DSA CODE AMENDMENT DEVELOPMENT

The Division of the State Architect (DSA) has prepared initial drafts of proposed code amendments for the 2016 Intervening Code Adoption cycle. The draft of each amendment is presented with the current code language, the suggested text of the proposed amendment, the code text if adopted and a rationale for the proposed change. The code amendments are listed below and will be presented at Access Code Stakeholder Forum scheduled for October 20, 2016.

Index of Code Amendments

Figure 11B-404.2.4.3
Maneuvering Clearances at Recessed Doors and Gates

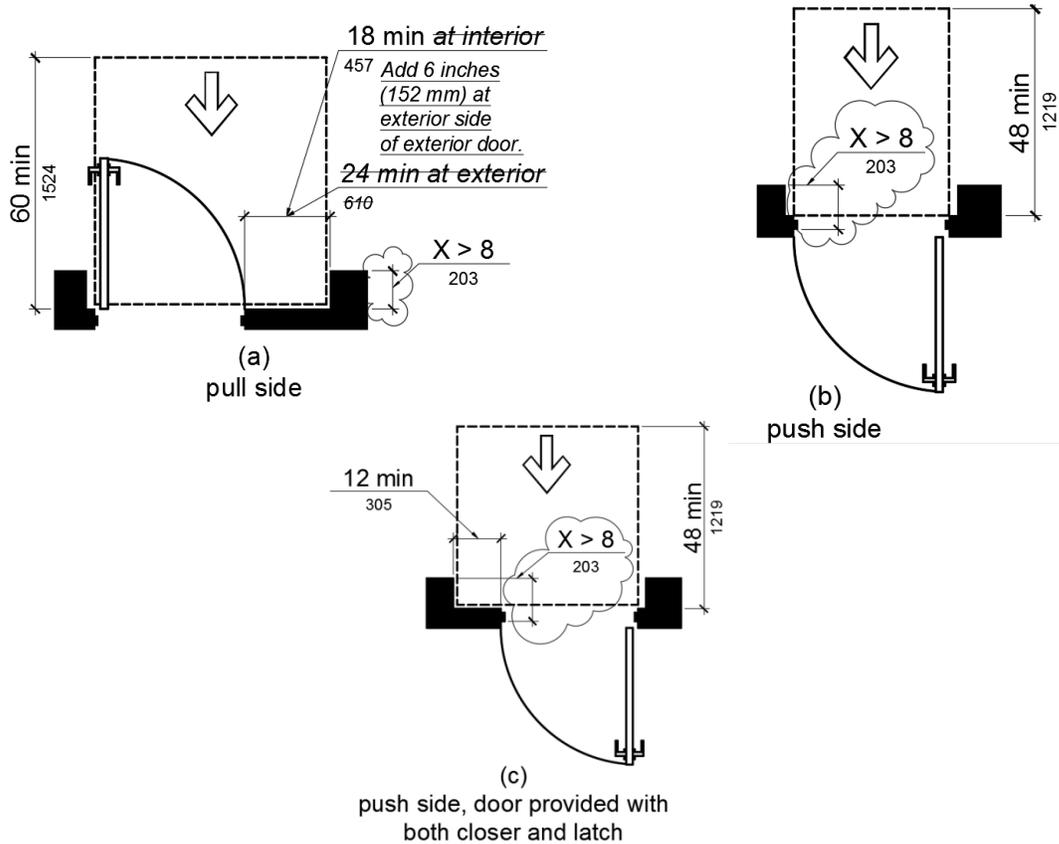
CBC Section 11B-404.2.6 requires maneuvering clearance for forward approach when any obstruction within 24 inches of the latch side of an exterior doorway projects more than 8 inches beyond the face of the door; this requirement is illustrated in Figure 11B-404.2.4.3(a). However, the maneuvering clearance dimensions for the strike side clearance width are not consistent with Figure 11B-404.2.4.1(a) which illustrates the required maneuvering clearance for forward approach at an exterior door which is not recessed. DSA proposes to amend the latch side clearance width dimension in Figure 11B-404.2.4.3(a) to be consistent with Figure 11B-404.2.4.1(a); this dimension will read: "18 min" followed by "Add 6 inches (152 mm) at exterior side of exterior door."

11B-404.2.4.3 Recessed doors and gates. Maneuvering clearances for forward approach shall be provided when any obstruction within 18 inches (457 mm) of the latch side at an interior doorway, or within 24 inches (610 mm) of the latch side of an exterior doorway, projects more than 8 inches (203 mm) beyond the face of the door, measured perpendicular to the face of the door or gate.

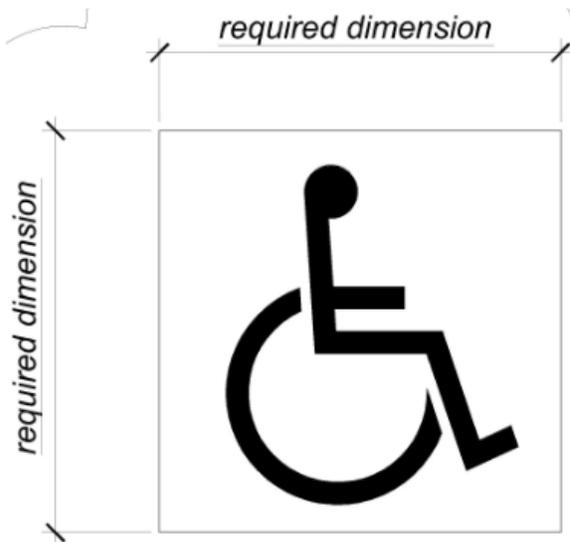
CBC Section 11B-502.6.4 requires an International Symbol of Accessibility (ISA) on the ground surface of standard accessible and van accessible parking spaces. DSA has received a number of questions about whether a border is required around the ISA; in response, DSA notes the text of the building code does not require a border around the ISA.

DSA is proposing to add permissive language which allows a border to be provided at the accessible parking ISA – either inside, at, or outside of the minimum required ISA dimension of 36" x 36".

11B-502.6.4.2 *The parking space shall be outlined or painted blue and shall be marked with an International Symbol of Accessibility complying with Section 11B-703.7.2.1 a minimum 36 inches wide by 36 inches high (914 mm by 914 mm) in white or a suitable contrasting color. A border may be provided inside, at, or outside of the minimum required ISA dimension. The centerline...*

**FIGURE 11B-604.7.1
DISPENSER OUTLET LOCATION**

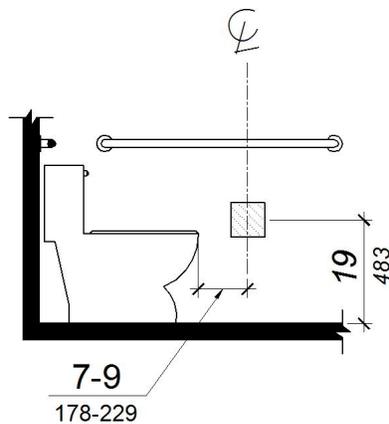
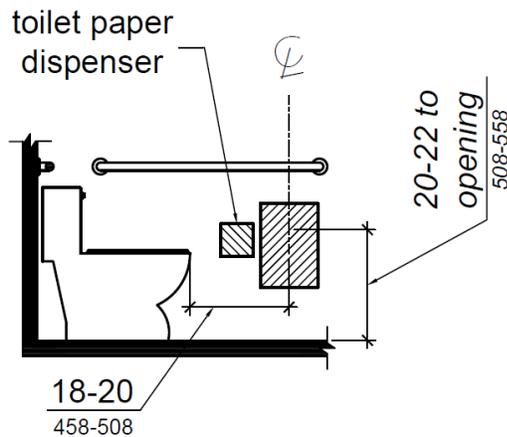
- The title of Figure 11B-604.7 will be changed to Figure 11B-604.7.1. Figure 11B-604.7.2 will be added to the California Building Code.

Figure 11B-703.7.2.1
International Symbol of Accessibility

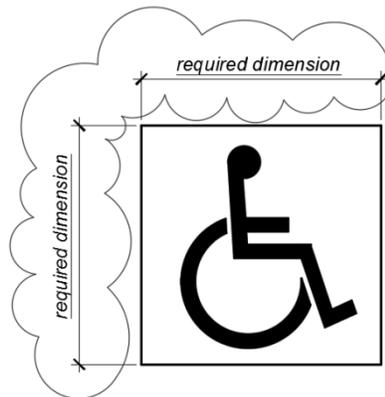
This amendment is proposed to provide code users with clarity for determining the dimension points when using the International Symbol of Accessibility.

11B-703.7.2.1 International Symbol of Accessibility. The International Symbol of Accessibility shall comply with Figure 11B-703.7.2.1. *The symbol shall consist of a white figure on a blue background. The color blue shall approximate FS 15090 in Federal Standard 595C.*

Figure 11B-705.1
Size and Spacing of Truncated Domes

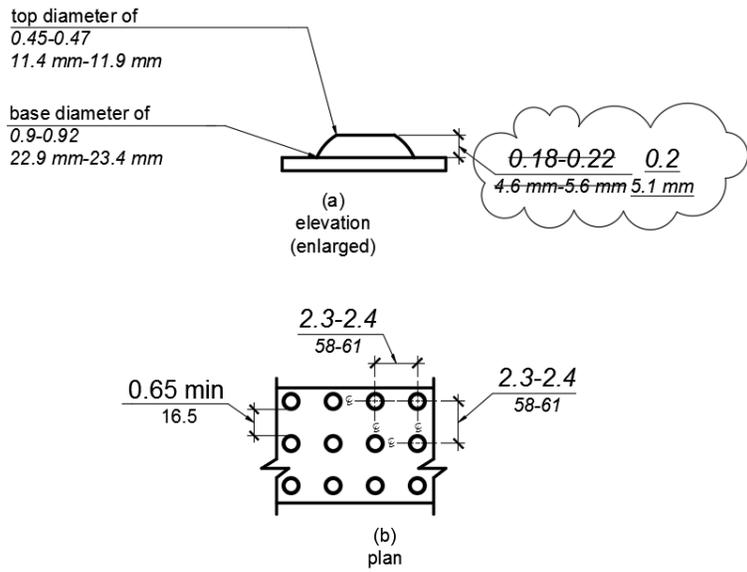
The revision occurs to the dimension in the figure for the height of the truncated domes. The proposed amendment will align the dimension in the figure to the code text that was amended during the rulemaking cycle for the 2016 triennial code.

- This revision is made in response to a comment from a code user who identified the discrepancy between the code text and the figure.

11B-705.1.1.1 Dome size. Truncated domes in a detectable warning surface shall have a base diameter of 0.9 inch (22.9 mm) minimum and 0.92 inch (23.4 mm) maximum, a top diameter of 0.45 inch (11.4 mm) minimum and 0.47 inch (11.9 mm) maximum, and a height of 0.2 inch (5.1 mm).
